INDEPENDENT ORBITER ASSESSMENT

**FMEA/CIL
ASSESSMENT
INTERIM REPORT**

9 MARCH 1988

WORKING PAPER NO. 1.0-WP-VA88003-40

Figure C.12a - ATCS FMEA/CIL ASSESSMENT

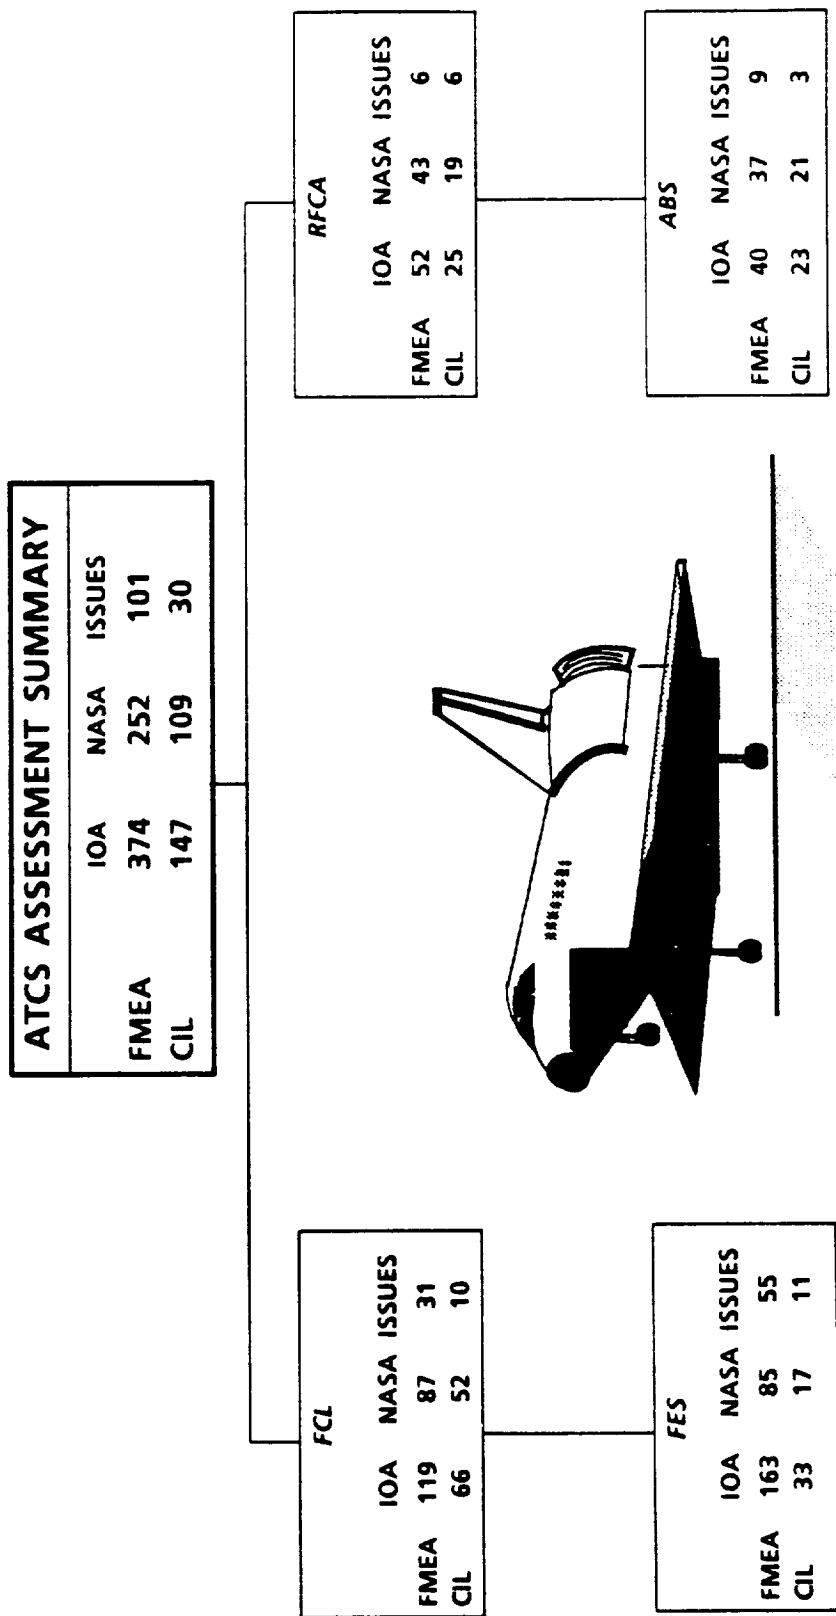
The ATCS Assessment Overview figure C.12a lists the total number of IOA and NASA FMEA and CIL items along with a comparison of the discrepancies or issues identified during the assessment. For analysis purposes, the ATCS was divided into 4 subsystems: the Freon Coolant Loop (FCL), the Radiator Flow Control Assembly (RFCA), the Flash Evaporator System (FES) and the Ammonia Boiler System (ABS).

The IOA analysis of the ATCS hardware initially generated 310 failure mode worksheets and identified 101 PCIs before starting the assessment process. In order to facilitate comparison, 74 additional failure mode worksheets were generated. Additionally, upon closer examination, IOA deemed 10 of the original failure modes to be non-credible and recommends deleting them. Thus, the final IOA analysis identified 374 FMEAs and 147 potential CILs. The analysis results were compared to the available NASA FMEA/CIL data. A total of 252 NASA FMEAs and 109 NASA CILs were identified. The discrepancy between the number of IOA and NASA FMEAs can be explained by the different approaches used by NASA and IOA to group failure modes. This resulted in multiple IOA FMEAs being mapped to a single NASA FMEA. However, every NASA FMEA is mapped to at least 1 IOA worksheet. A total of 101 FMEA and 30 CIL issues were identified on the ATCS. A number of these issues involved failures which were identified by IOA but not by NASA. These included external leakage of heat exchanger fluid and external leakage of water/steam from the FES ducts. These failures plus the remaining issues should be examined by NASA and included in the FMEA package as required.

Figure C.13 - CREW EQUIPMENT FMEA/CIL ASSESSMENT

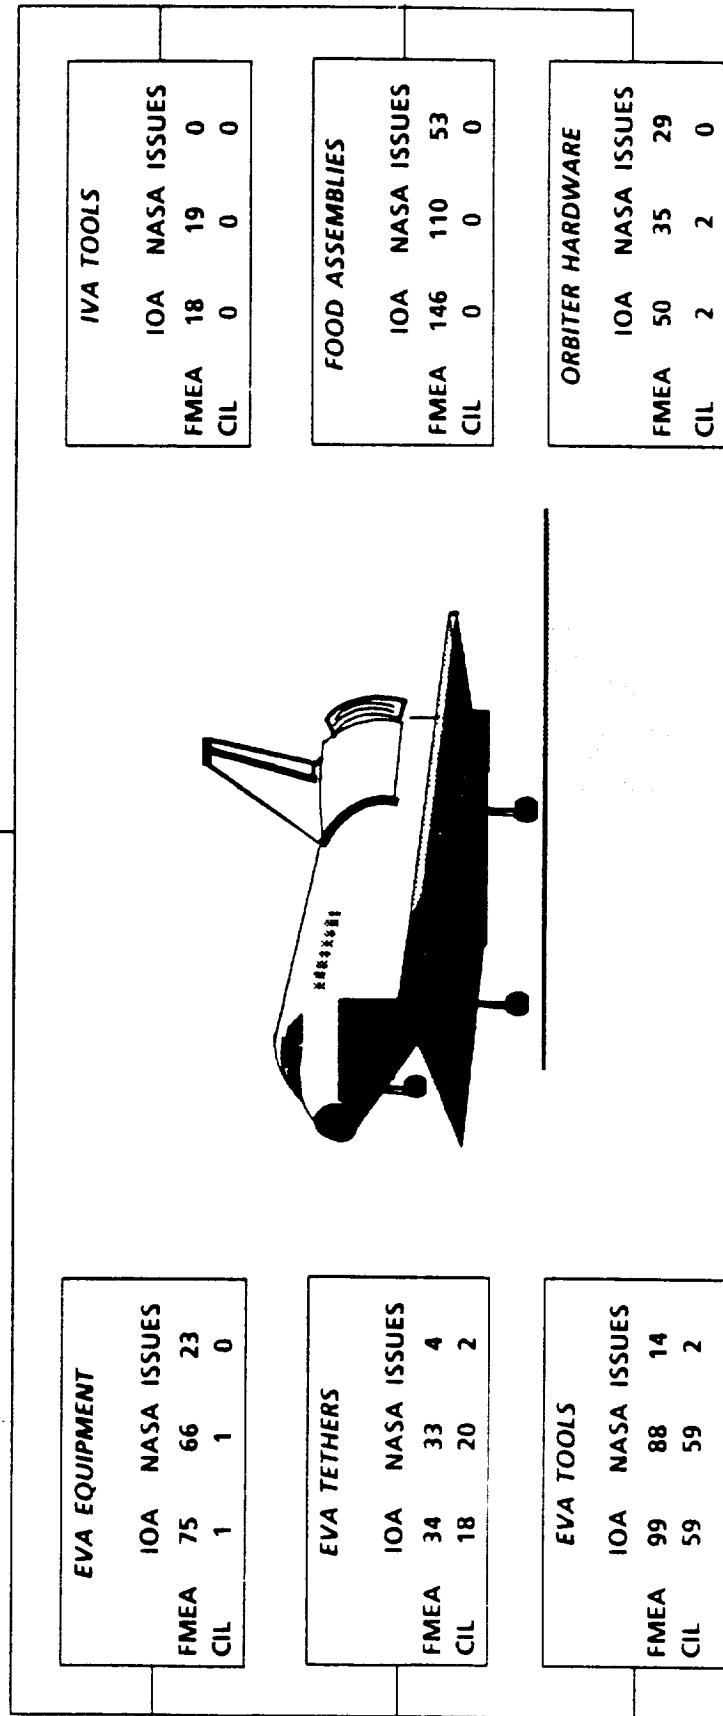
An overview of the quantity of NASA FMEAs assessed, versus the recommended IOA baseline, and any issues identified is presented in Figure C.13.

Figure C.16 - ARPCS FMEA/CIL ASSESSMENT

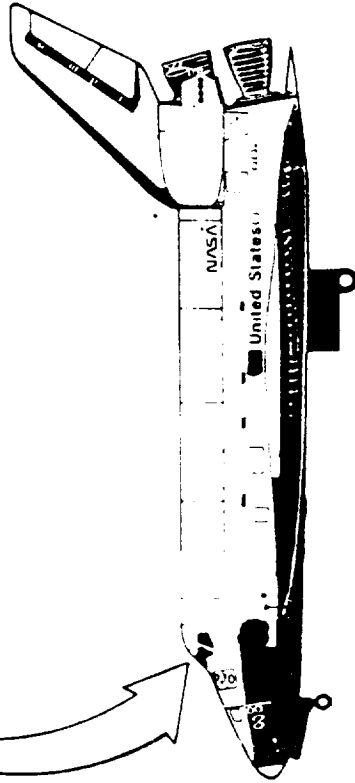
These analysis results were compared to the proposed NASA Post 51-L baseline of 262 FMEAs and 87 CIL items. Upon completion of the assessment, of the 273 total IOA failure modes, 124 remained as issues to be resolved. A summary of the FMEA/CIL counts for IOA and NASA is provided in Figure C.16, and some of the significant issues follow.

Figure C.18 - MAS ASSESSMENT

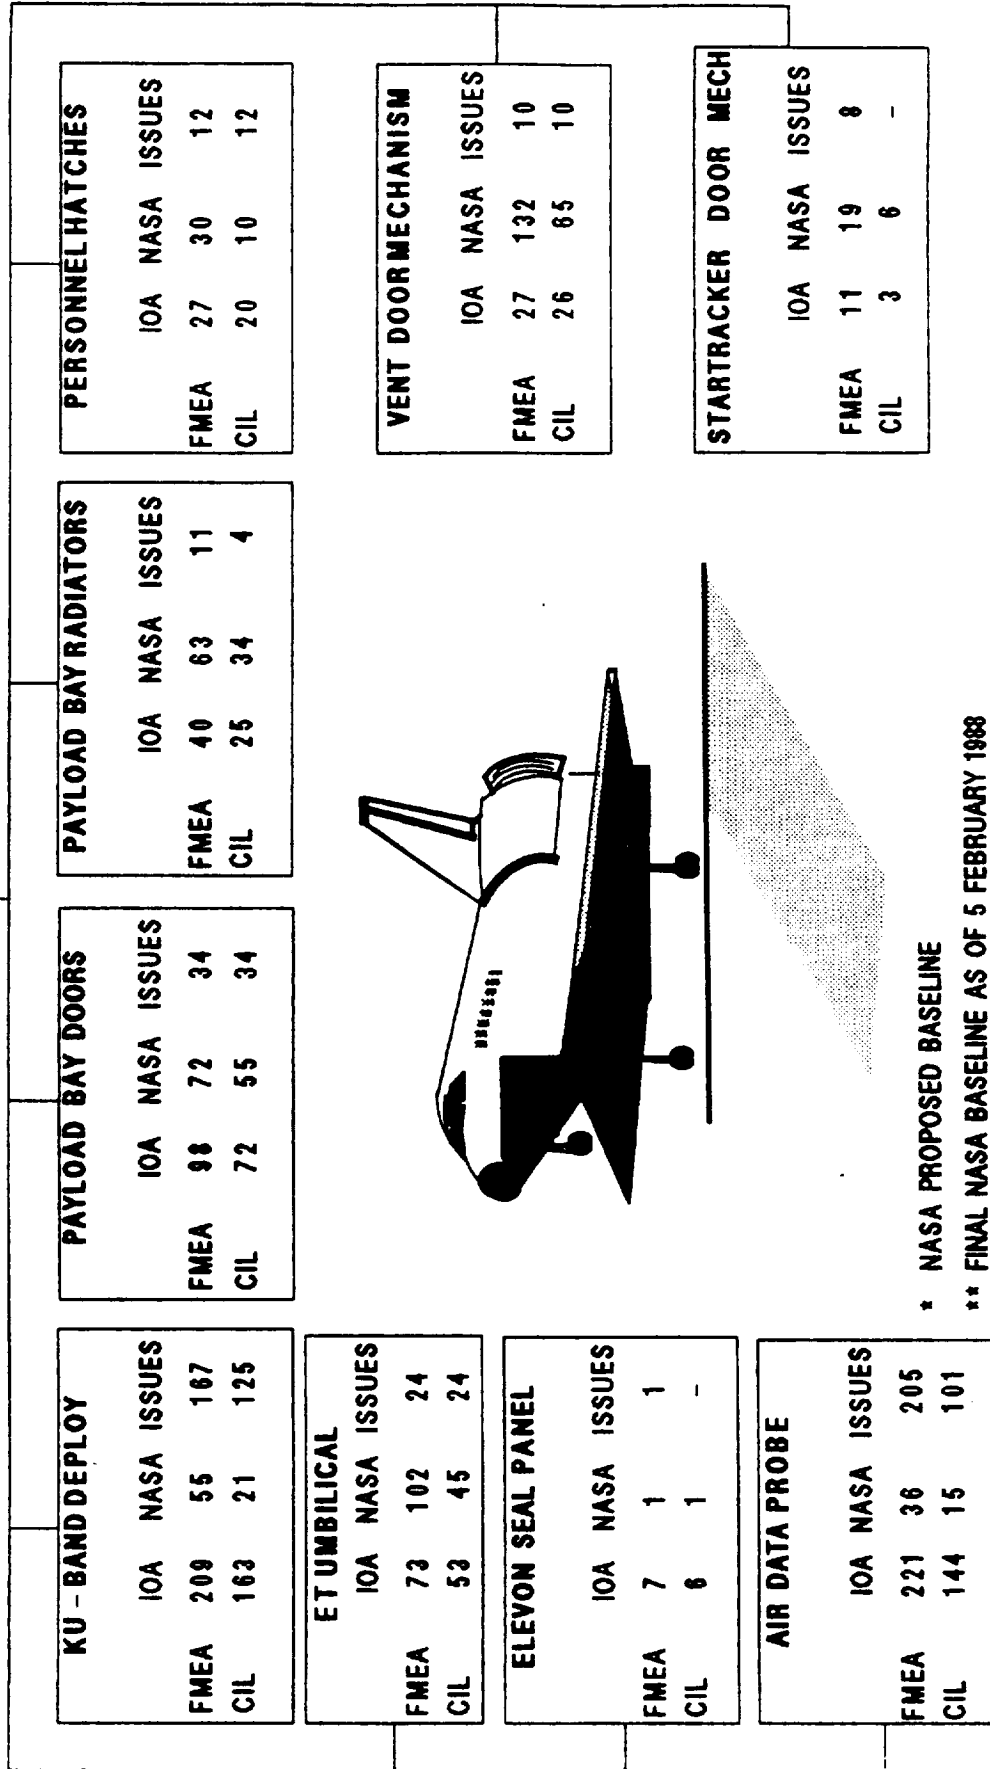
An overview of the quantity of NASA FMEAs assessed, versus the recommended IOA baseline and any identified issues, is presented in Figure C.18. In the analysis and assessment report, the MAS was divided into nine sections according to hardware and function. Each of these sections are identified, with summary assessment results, in Figure C.18.

The IOA analysis of the MAS hardware initially generated 685 failure mode worksheets and identified 476 Potential Critical Items (PCIs) before starting the assessment process. In order to facilitate comparison, 28 additional failure mode analysis worksheets were generated. These analysis results were compared to the proposed NASA Post 51-L baseline (5 February, 1988) of 510 FMEAs and 252 CIL items using available NASA FMEA/CIL data. The discrepancy between the number of IOA and NASA FMEAs can be explained by the different approach used by NASA and IOA to group failure modes. In many cases, multiple IOA FMEAs were mapped to a single NASA FMEA. The MAS assessment identified a total of 472 issues. Many of these issues resulted from failures identified by IOA which could not be matched to available NASA FMEAs. It is believed that other issues resulted from IOA use and interpretation of NSTS-22206 differing slightly from criteria used by RI and NASA, and a difference in criticality assignments for a particular hardware item or function.

Figure C.19 - MMU FMEA/CIL ASSESSMENT

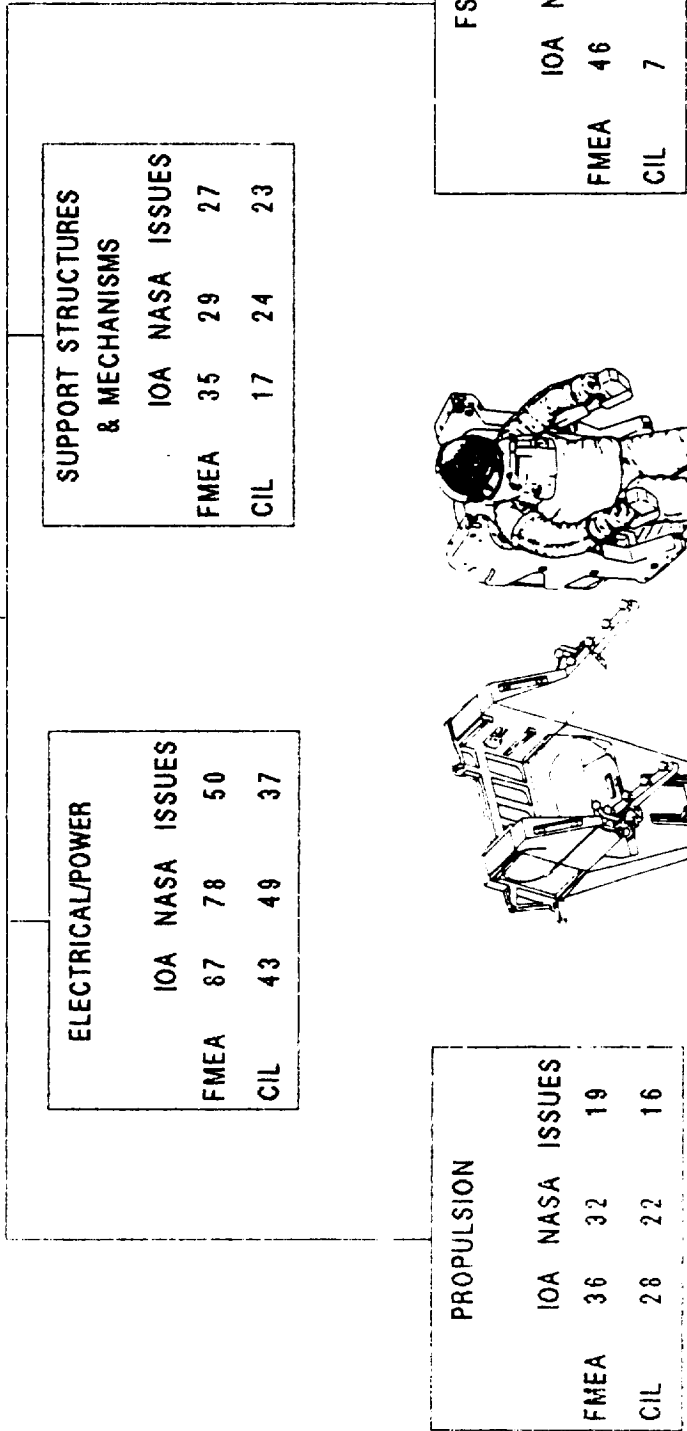
The IOA analysis of the MMU hardware initially generated 136 failure mode worksheets and identified 69 PCIs before starting the assessment process. In order to facilitate comparison, 57 additional failure mode analysis worksheets were generated. These analysis results were compared to the proposed Martin Marietta Post 51-L baseline of 179 FMEAs and 110 CIL items. Upon completion of the assessment, 121 of the 204 IOA failure modes remained as issues to be resolved. A summary of the FMEA/CIL counts for IOA and NASA is provided in Figure C.19, and some of the significant issues follow.

The MMU PREP and POST-OPS definitions were not too clear, and it was consequently difficult to match their criticalities. IOA considered every MMU activity to begin with PRE-OPS activities and end with POST-OPS activities prior to the start of the next MMU OPS. The Martin Marietta definition seems to suggest that the PREP activities start with the first MMU PRE-OPS and stop after the last MMU OPS activity. The period after the last planned MMU OPS will then be POST-OPS.

Figure C.20 - NWS ASSESSMENT

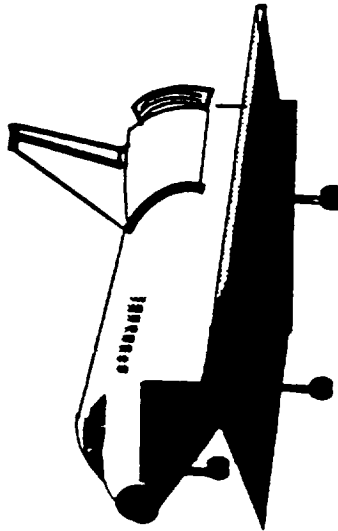
The IOA analysis of the NWS hardware initially generated 78 failure mode worksheets and identified 42 Potential Critical Items (PCIs). As a result of the assessment process, 15 NWS

failure mode worksheets were deleted and an additional 5 analysis worksheets were generated and added to the assessment package. The assessment comparison also gave rise to 14 issues between the IOA NWS analysis and the corresponding NASA FMEAs (Fig. C.20).

Figure C.22 - ARS ASSESSMENT

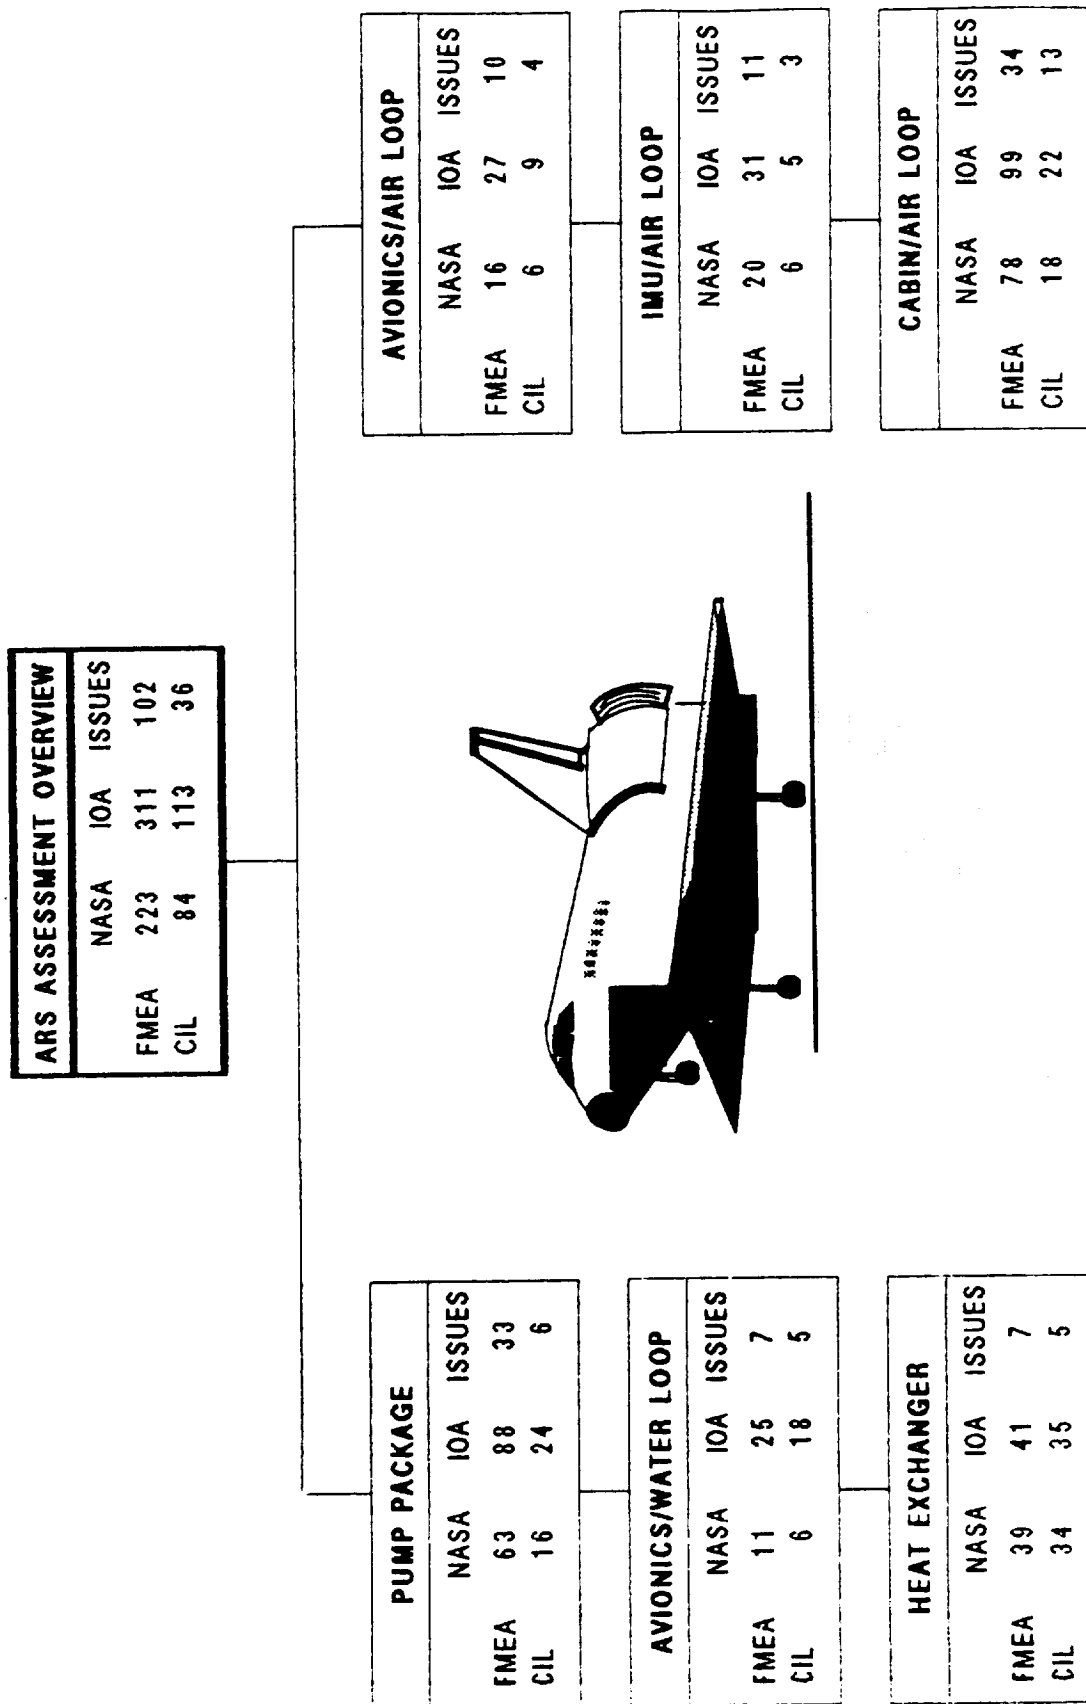
The ARS Assessment Overview figure C.22 lists the total number of IOA and NASA FMEA and CIL items, along with a comparison of the discrepancies or issues identified during the assessment. For analysis purposes, the ARS was divided into 6 subsystems: the Pump Package, the Avionics/Water Loop, the Heat Exchanger, the Avionics/Air Loop, the IMU/Air Loop and the Cabin/Air Loop.

The IOA analysis of the ARS hardware initially generated 245

failure mode worksheets and identified 84 PCIs prior to starting the assessment process. In order to facilitate comparison, 74 additional failure mode worksheets were generated and 8 of the original worksheets were deleted. Thus, the final IOA analysis identified 311 FMEAs and 84 potential CILs. The analysis results were compared to the available NASA FMEA/CIL data. A total of 223 NASA FMEAs and 84 NASA CILs were identified. The discrepancy between the number of IOA and NASA FMEAs can be explained by the different approaches used by NASA and IOA to group failure modes. This resulted in multiple IOA FMEAs being mapped to a single NASA FMEA. However, every NASA FMEA is mapped to at least 1 IOA worksheet.
